AGENDA

Historic District Commission Meeting

7:00 PM - Tuesday, July 11, 2023

HDC Work Permit Staff Review

Sanborn Map Images of 206 N River

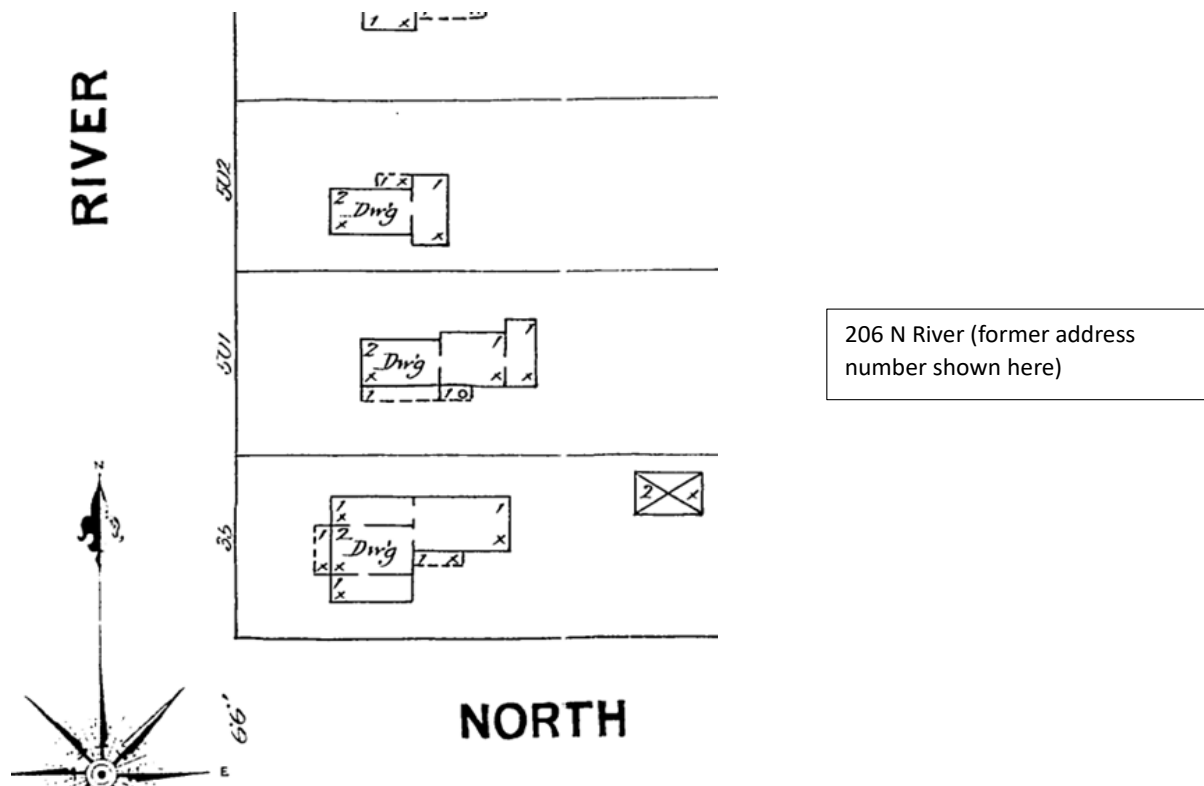
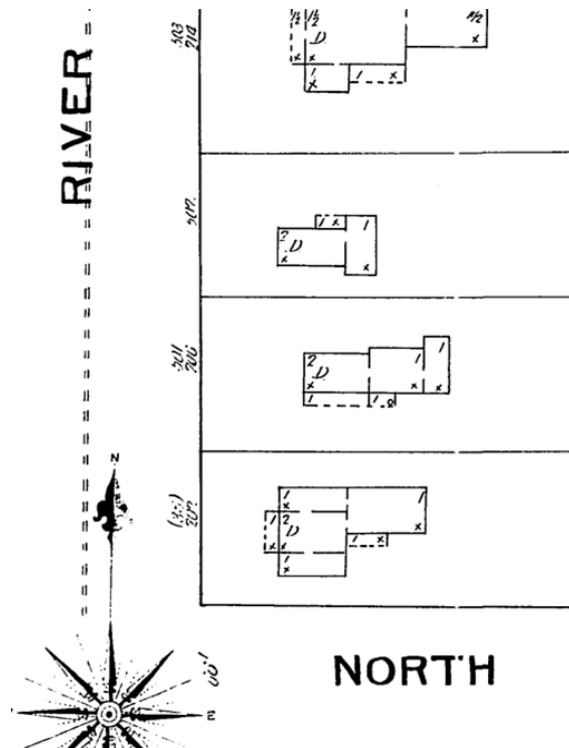
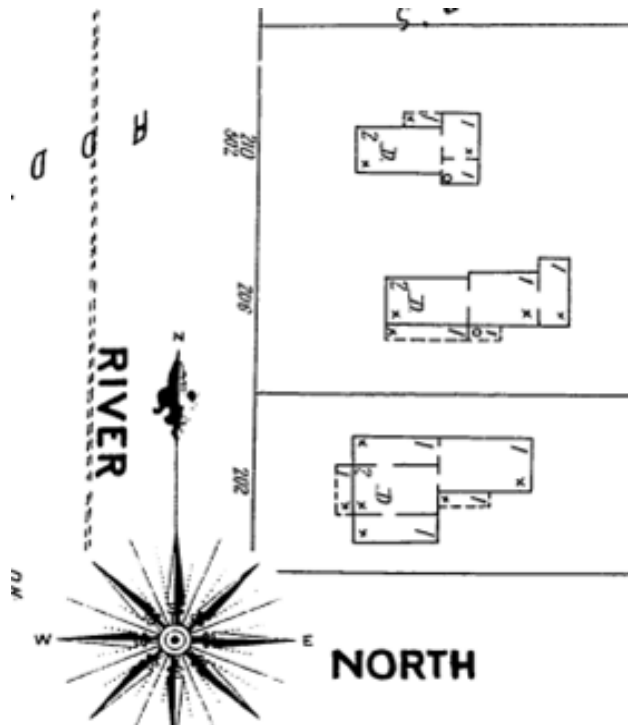
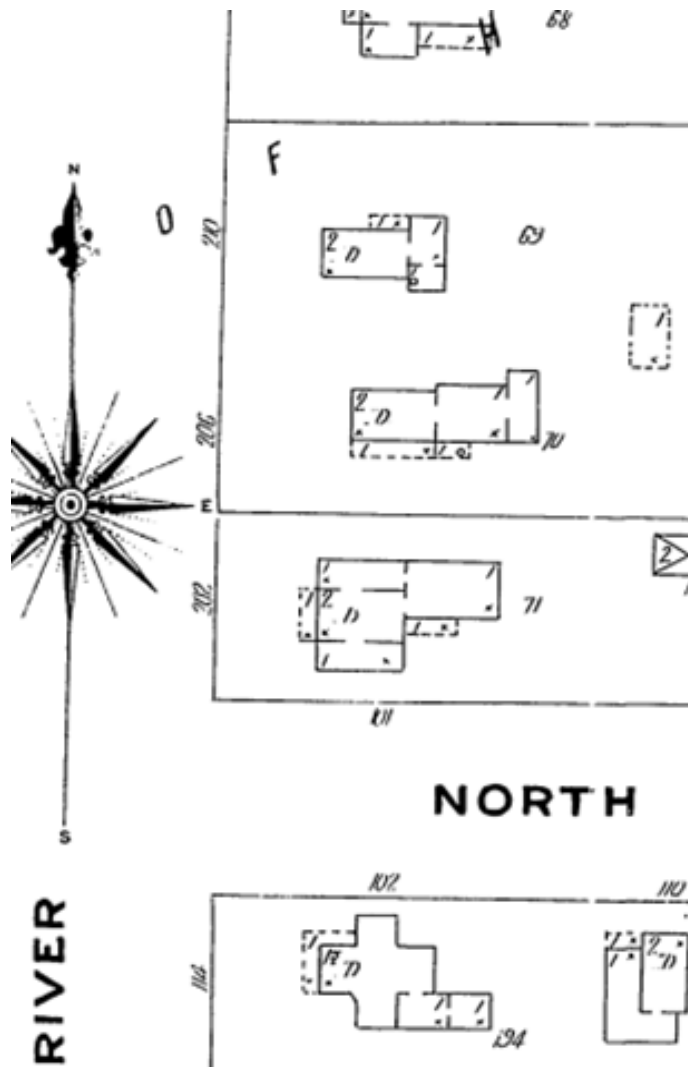
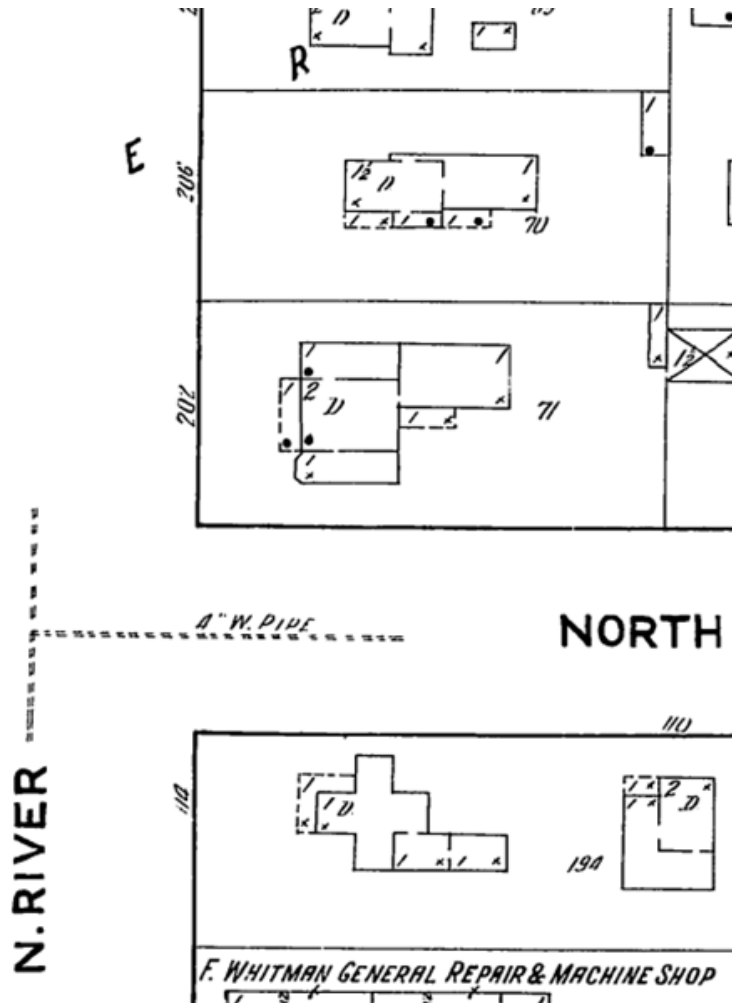
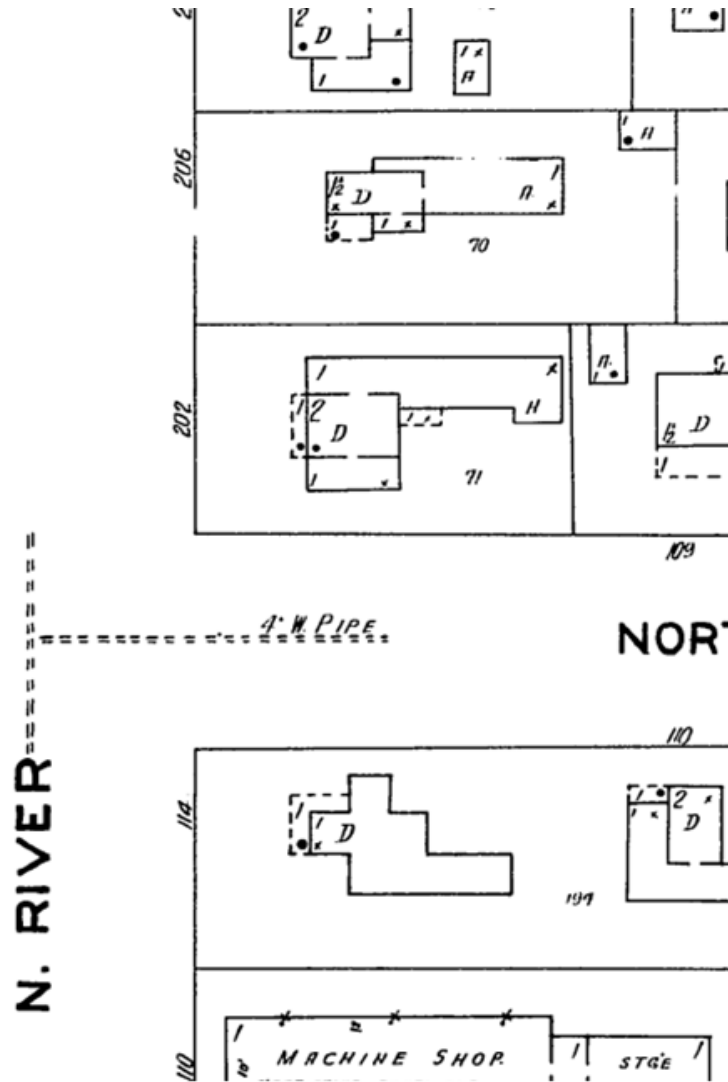
The house appears on the 1855 birds-eye-view map of Ypsilanti, and it has had its current configuration since about 1916. (The current addition at the rear of the house that is used as a garage was added between 1909 and 1916. See attached images from Sanborn maps.)

Because this garage is attached to the house and has been in place since about 1915, staff finds that this portion of the house is historic and its wood siding is a character-defining feature.
